1110-G-m COE Ingr & Des Corres Files-
Subject: Lake Pont. LA, Vic. , Hurricane Protection
Project , HLP, N.O. Lakefront London AVE. Canal to
West End Blvd. Orleans Parish LA

Modification to Contract DACW29-85-C-0171, Lake Pont. LA, & VIC,
Hurricane Protection Project, HLP, New Orleans Lakefront Levee,
London Ave. Canal to West End Blvd.

LMVED-TL (LMNED-DL/18 Jul 85) 1st End Mr. Burkhard/jae/5930
SUBJECT: Lake Pontchartrain, Louisiana and Vicinity, Lake Pontchartrain High Level Plan, New Orleans Lakefront Levee, London Ave. Canal to West End Blvd, Orleans Parish, Louisiana

VICINITY OF STA. 290+40 (TIE-IN WITH
 TYPICAL UTILITY CROSSINGS) TO THE VIC.
 OF STA. 293+55

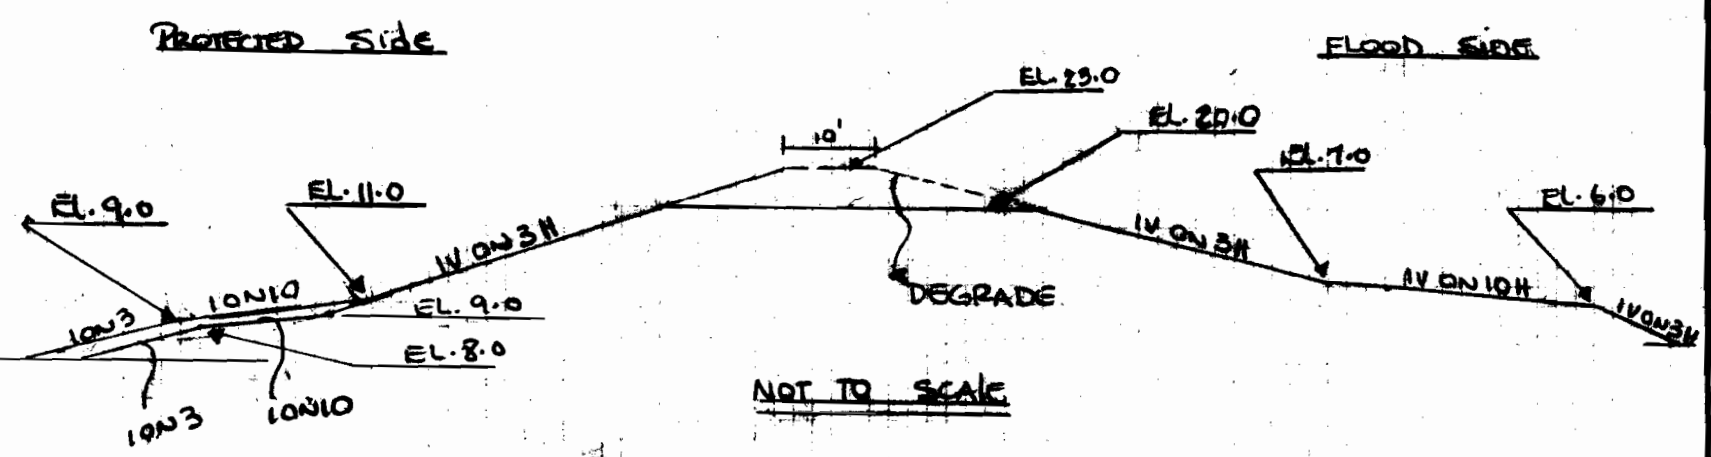
1. Furnished as enclosure 1 is an interim section intended to stop the progression of the existing failure in the vicinity of B/L sta 290+40 to the vicinity of B/L sta 293+55.
2. A revised final design section will be furnished after cross sections of the failure area are furnished.

LAKE PONTCHARTRAIN, LA. - Vicinity
 New Orleans Lakefront Levee
 Utility Crossings.
 Protected Side Stability Analysis
 Sta. 289+49.52 TO 303+51.39
 July 85

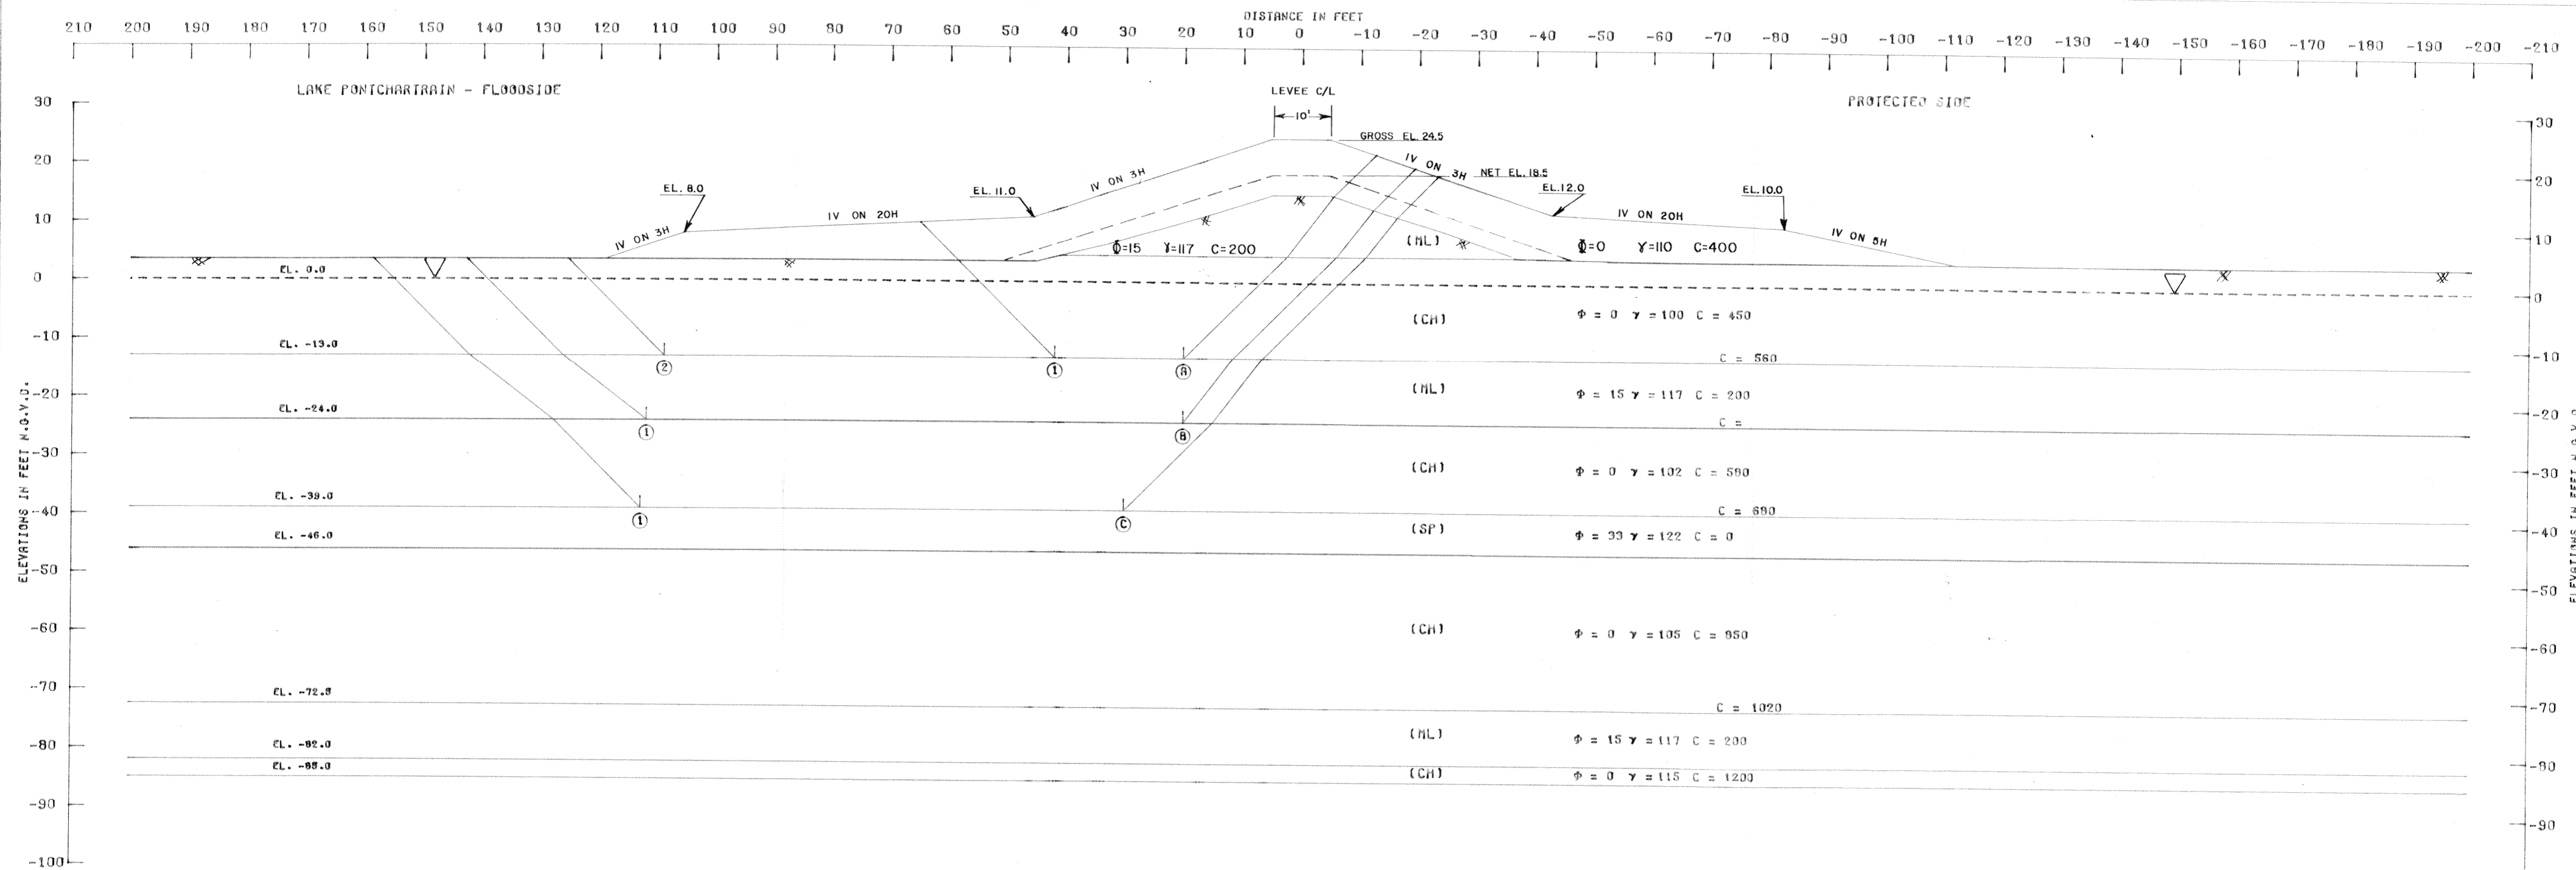
(1) The change. The protected side berm between Sta. 289+20 B/L to Sta. 292+40 B/L has been enlarged.

b. Necessity for change. The enlarged protected side berm is necessary as a corrective action to embankment slide during construction of levee in this area.

(3) Contract Drawings. Drawings 7 & 11 of 19, file no. H-8-29721 dated July 1985 are deleted and revised drawings 7 & 11 of 19 file no. H-8-29721 bearing revision no. 1 is substituted therefor.
